Staff Report Z-57-19-1 March 9, 2020

Proposed Use: Multifamily Residential

Location: Approximately 435 feet north of the

Applicant: MK Company, Inc.

CONCEPTUAL ELEVATION - A

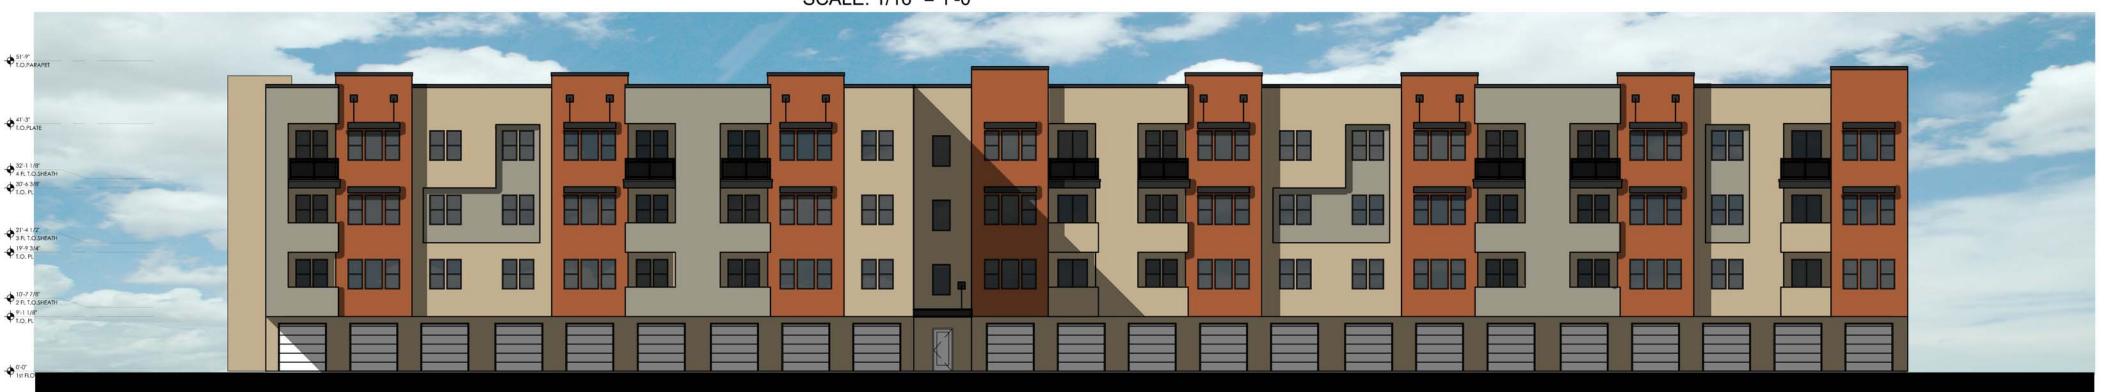
- 11. Staff is recommending a series of stipulations related to the building elevations to promote an environment conducive of walking, bicycling, and transit use.

- a. Architectural embellishments (Stipulation No. 4): The intent of this stipulation is to add visual interest and additional design consideration later in the site plan review process.

- b. Prominent corners at the northwest and southwest corner of the building mass (Stipulation No. 5): The intent of this stipulation is to add visual interest to the building, form a connection between the building, the canal, the street, and the remainder of the North Mountain Village Core north of the canal.

- c. Individual garage entrances shall not be visible from the north and west site boundaries (Stipulation No. 13)
 - d. Requiring porches and patios along the north and west frontages of the building to facilitate additional pedestrian interaction with the street, canal, and surrounding environment. These are addressed in Stipulation Nos. 11 and 12 respectively with examples contained in Figure D.

- 4. All elevations of the building shall contain architectural embellishments and detailing such as textural and materials changes, offsets, recesses, variation in window size and location, and/or other overhang canopies, as approved by the Planning and Development Department.

- 5. The development shall include architectural focal points at the northwest and southwest corners of the building mass which may be achieved through additional building articulation, height, and/or enhanced glazing to emphasize the corners and increase resident activity, as approved or modified by the Planning and Development Department.
